RE: 133 E. Lakeside Street (VFW) Development

The Bay Creek Neighborhood Association is submitting the following graphics and this letter in response to the proposed development at 133 E. Lakeside Street, which is the current location of the VFW post 1318.

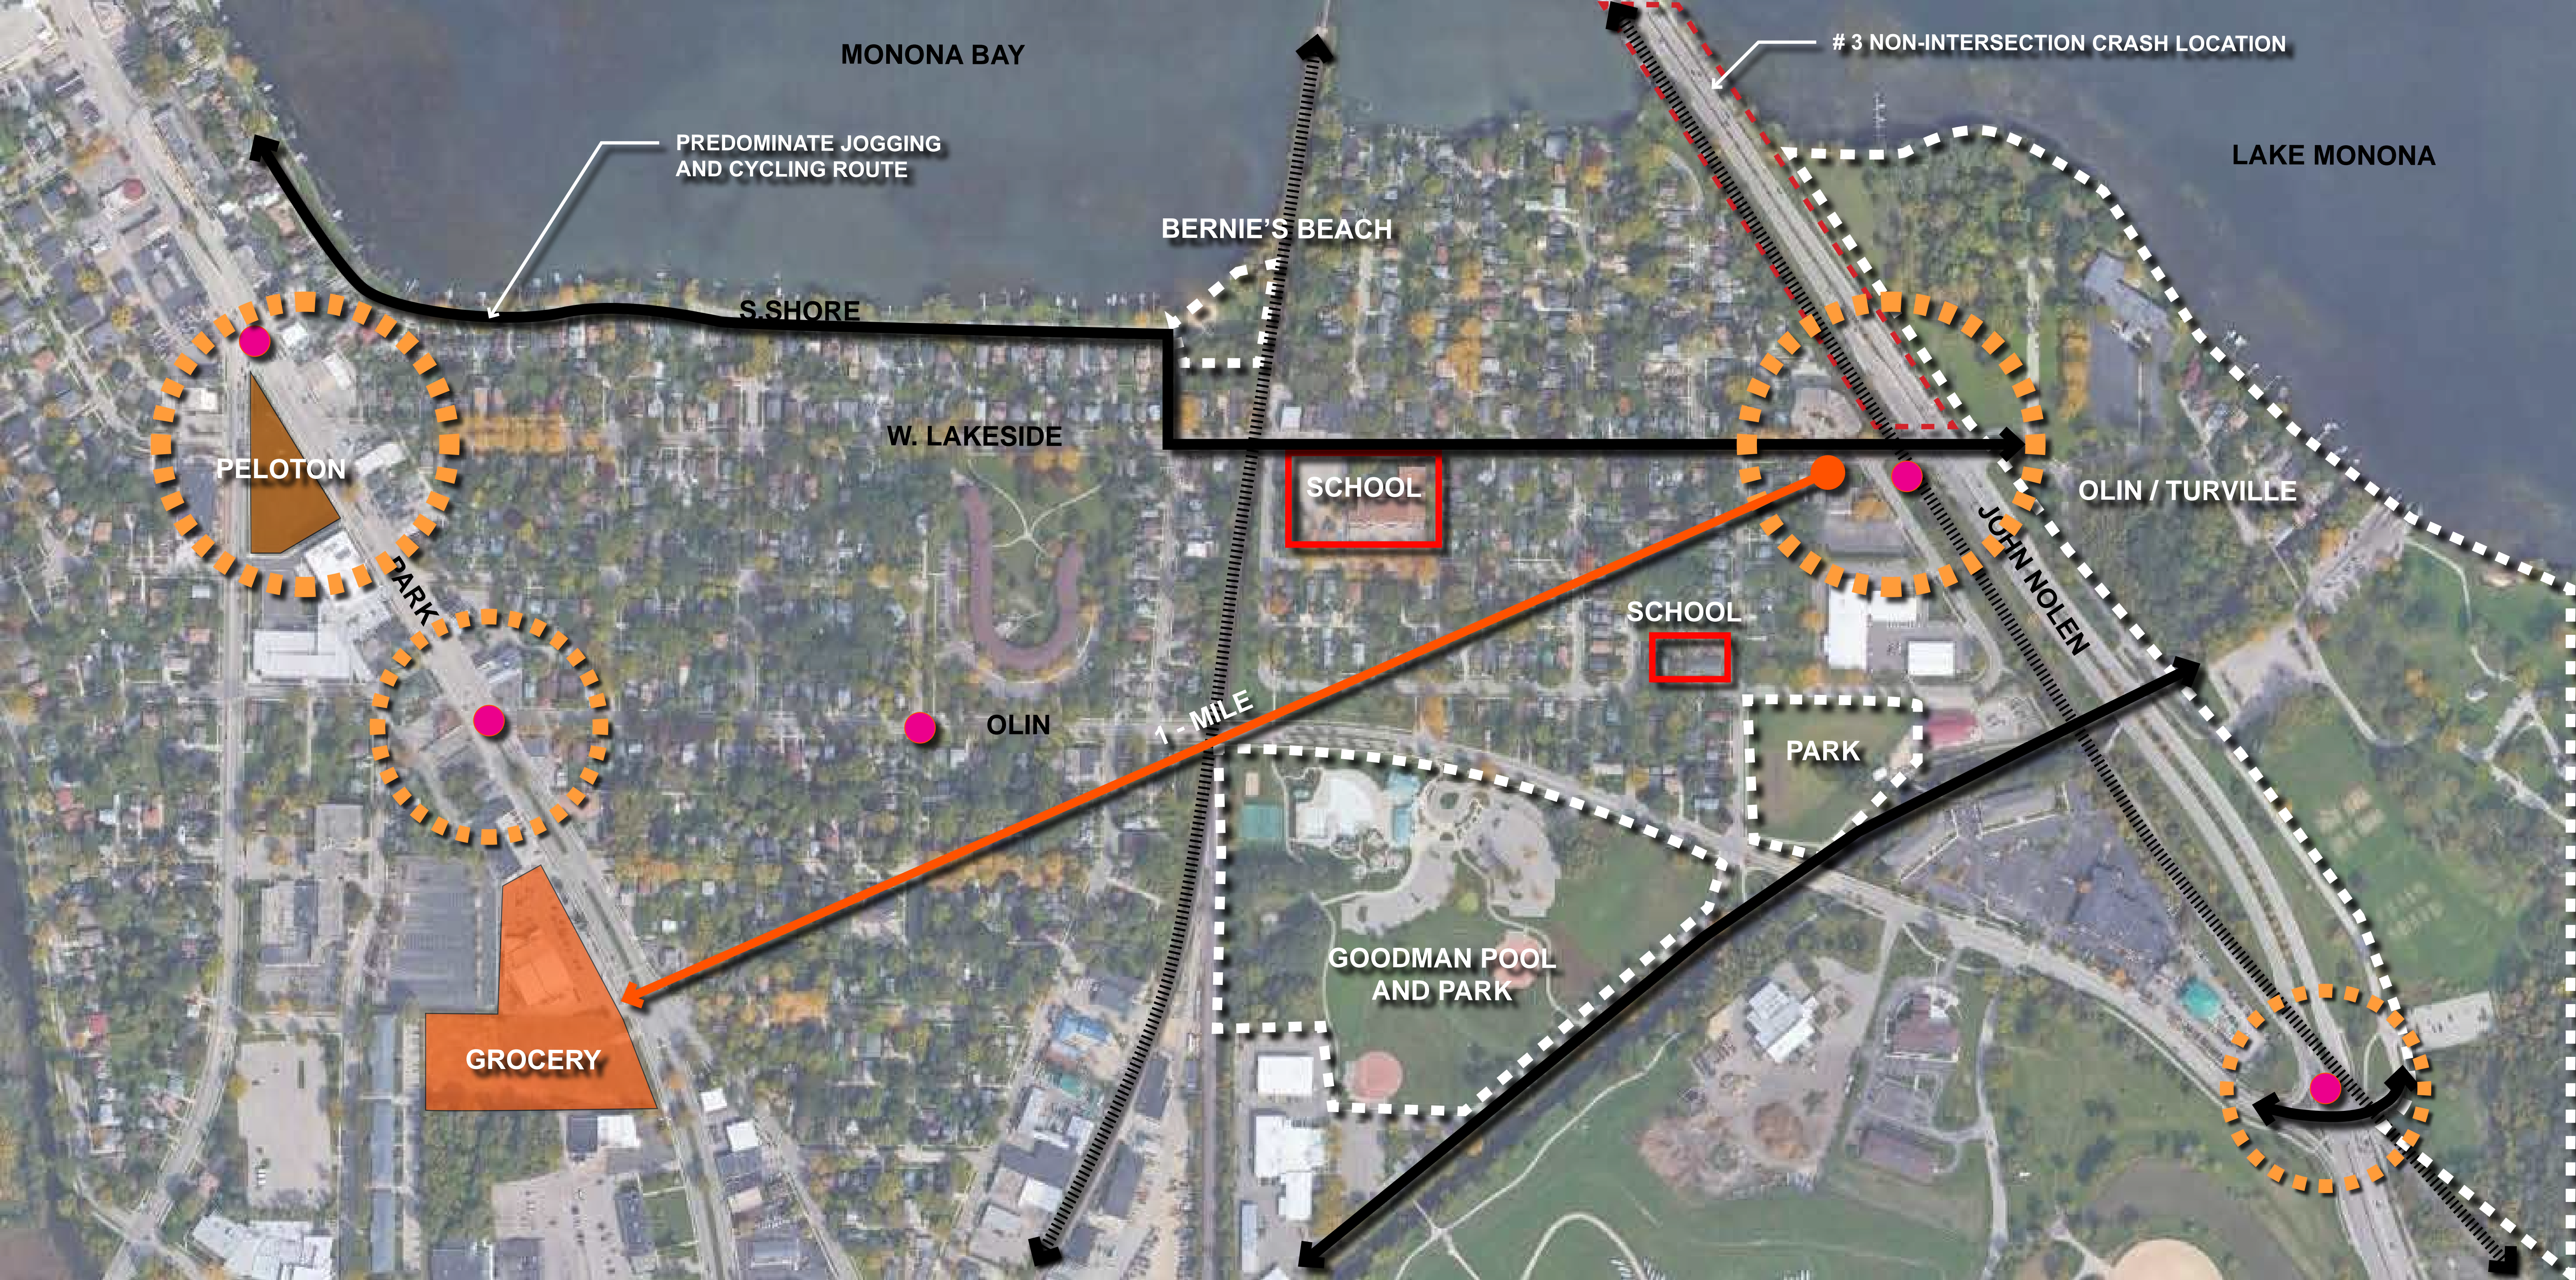
1. No speed control on Lakeside (no stop signs the entire length)
2. Several official City reports dating back to 2005 suggested traffic control measures to reduce vehicular speed on Lakeside.
3. 1/4 mile walk (5 minutes) is as far as most people are willing to walk before driving (Congress for the New Urbanism)
4. John Nolen, within the Bay Creek Neighborhood, is ranked as the 3rd highest non-intersection crashes (City of Madison's 2018 Crash Facts)

5. 2025 proposed reconstruction of JN from Olin to north of causeway
6. Limited bicycle safety facilities or directional signage or road markings within the neighborhood

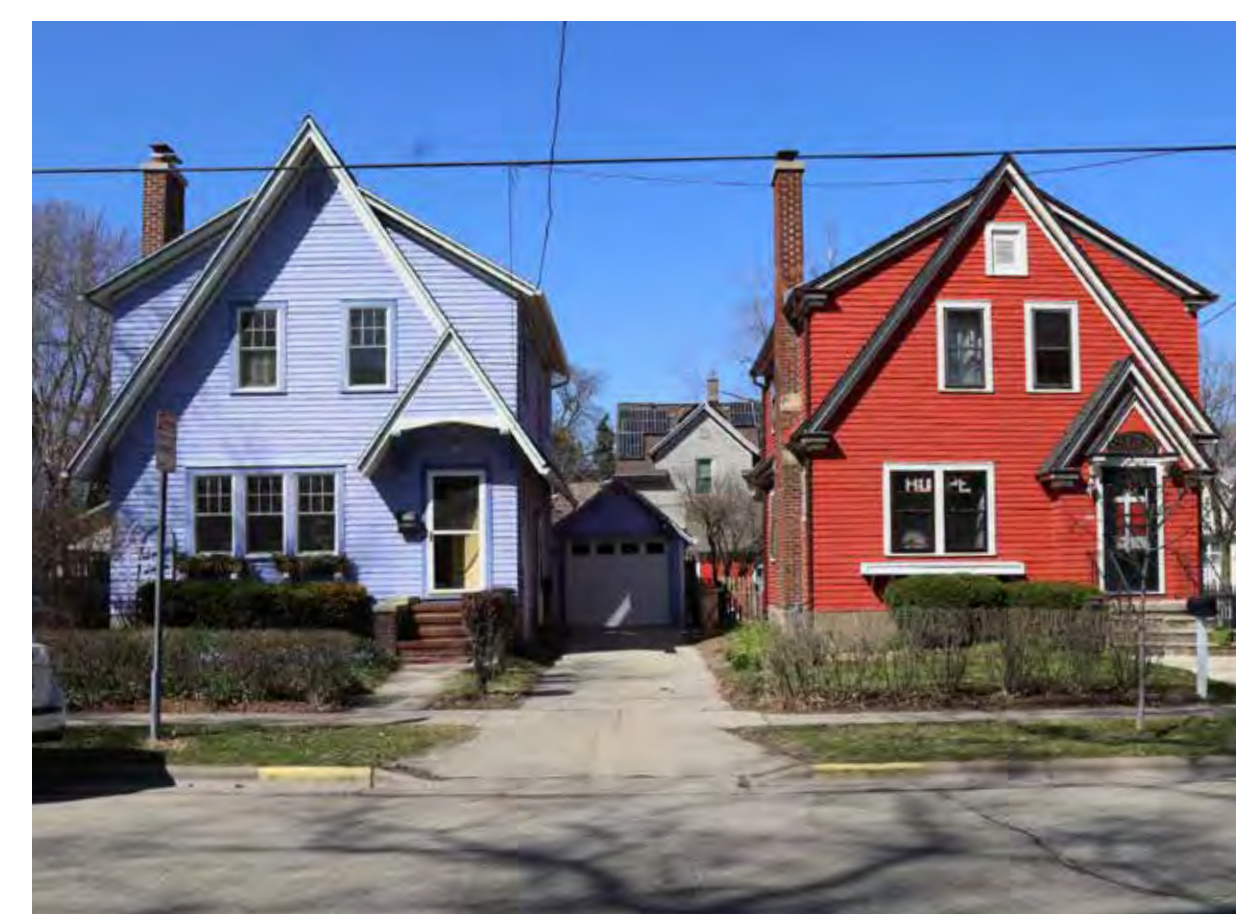
LARGER THAN THE EXISTING
ELEMENTARY SCHOOL

IMAGE 1: SAYLE AND E. LAKESIDE

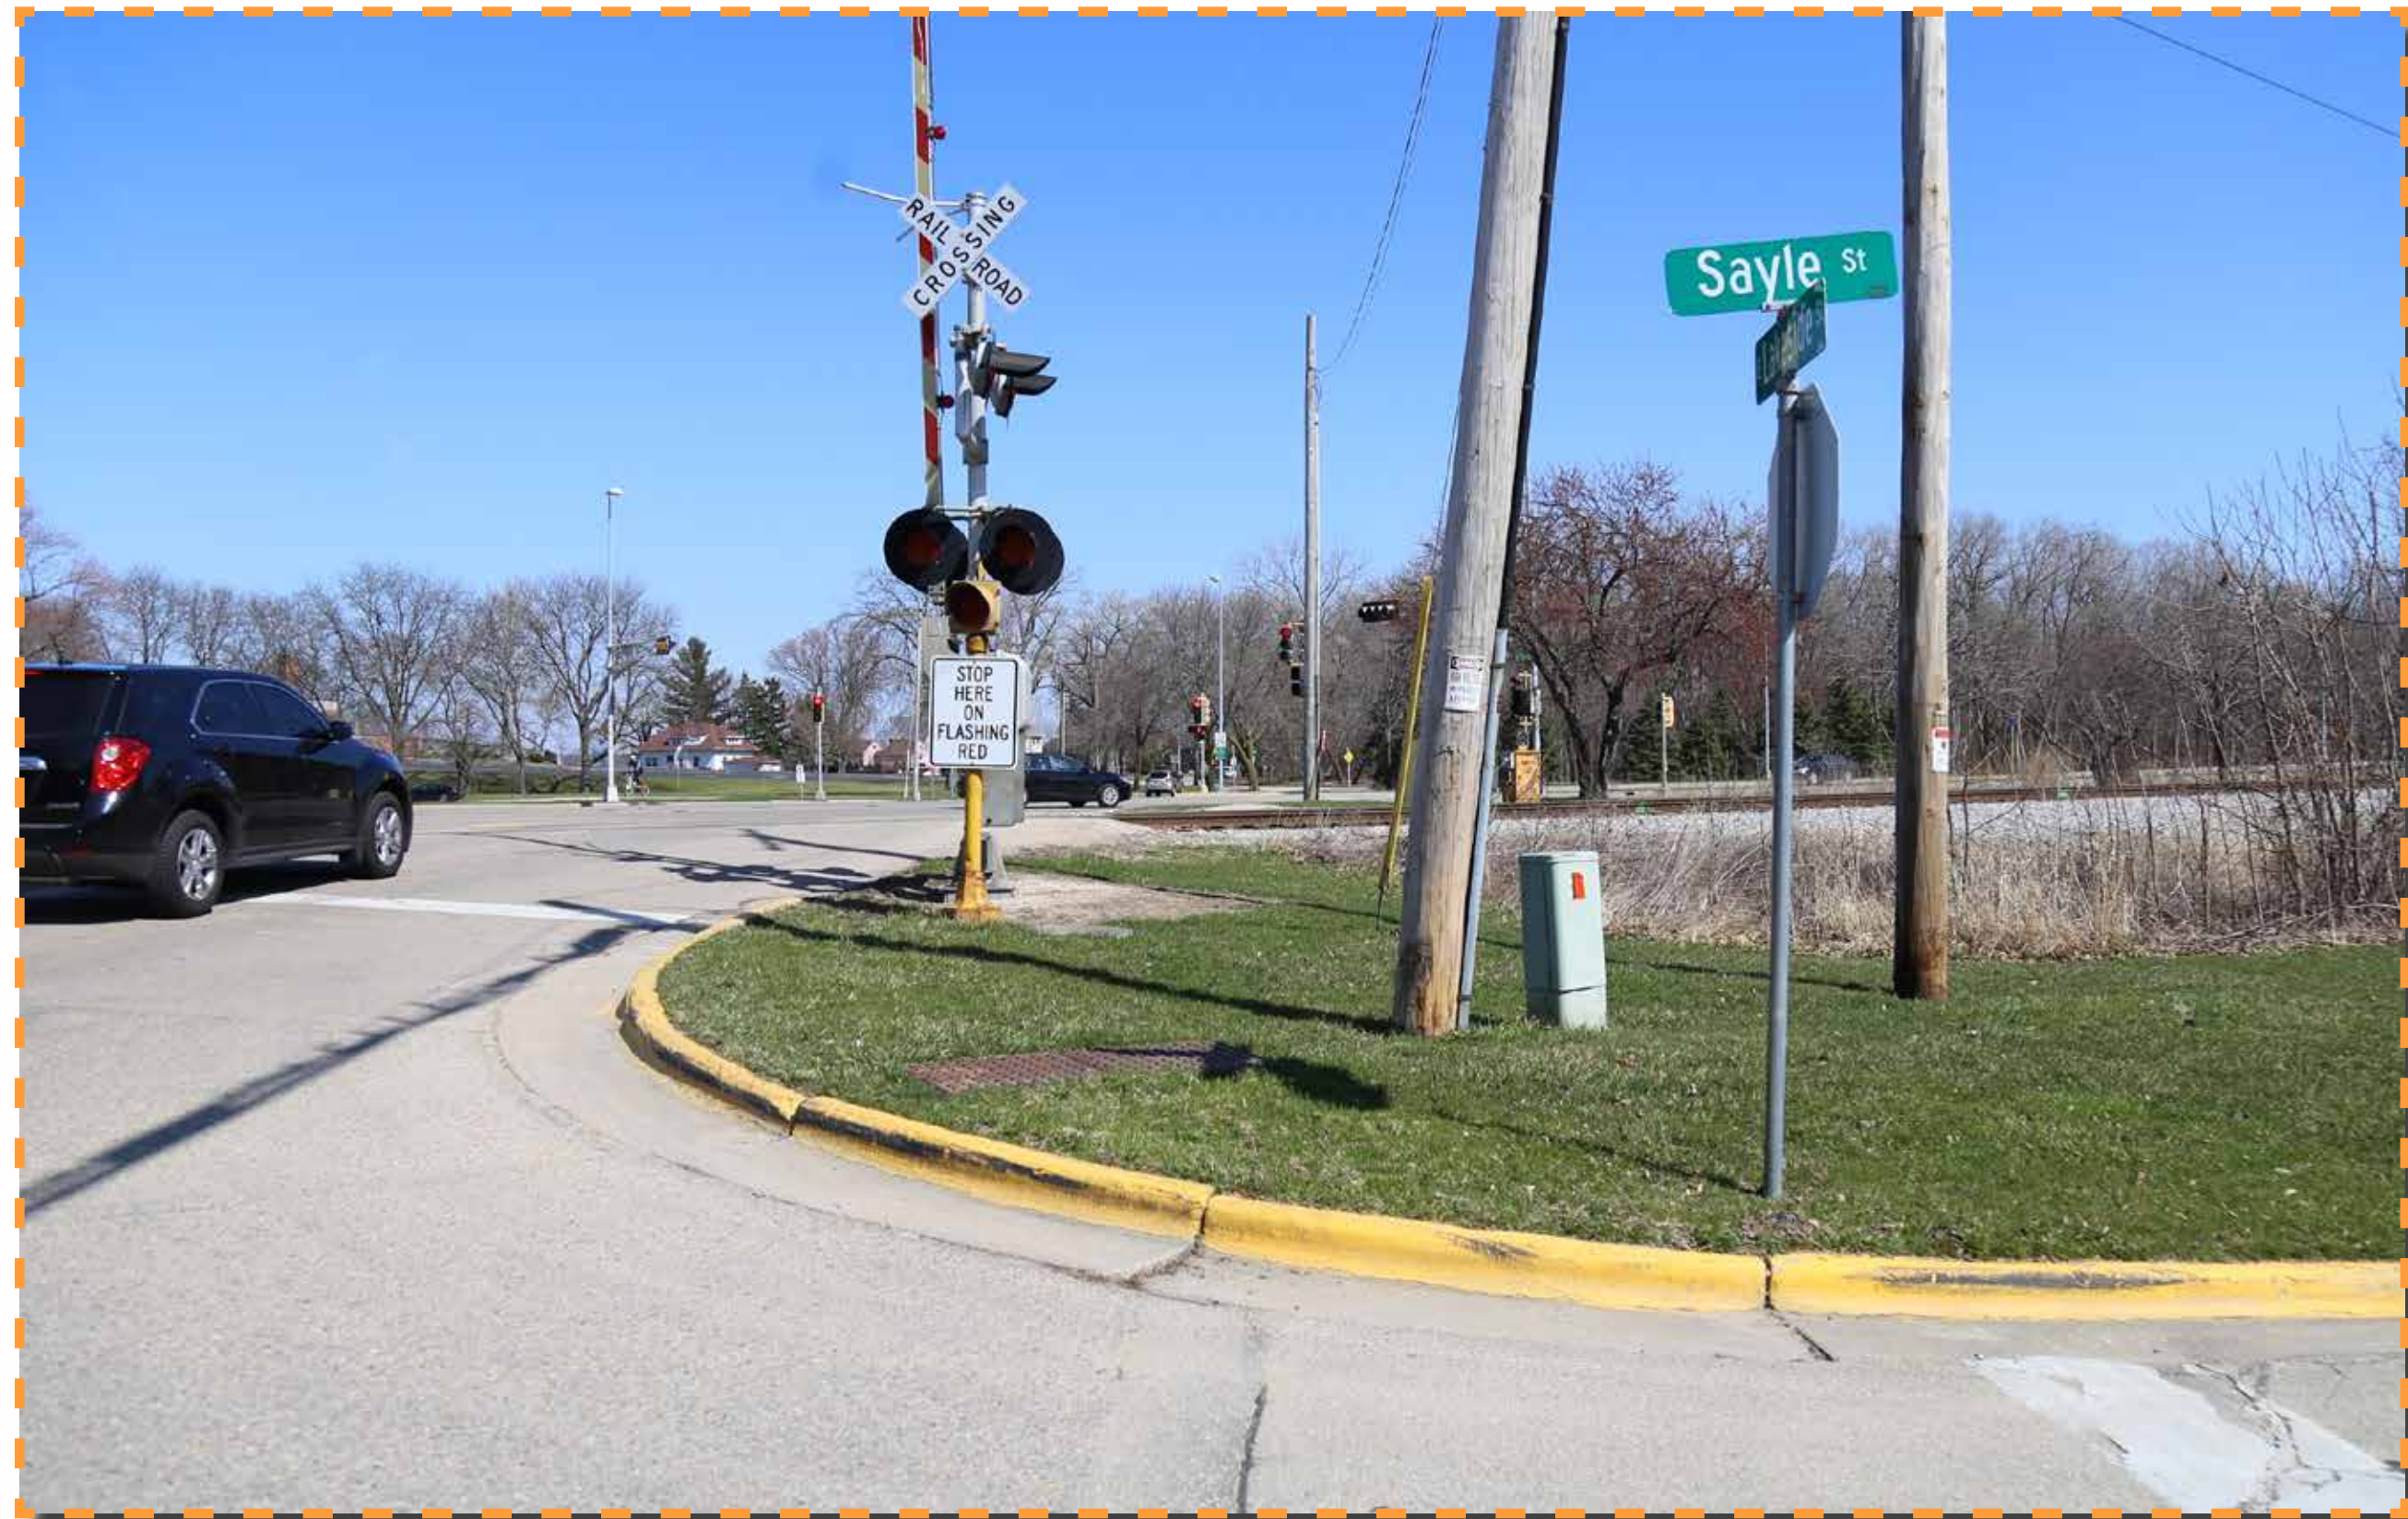
SOLUTION: proposed south sidewalk
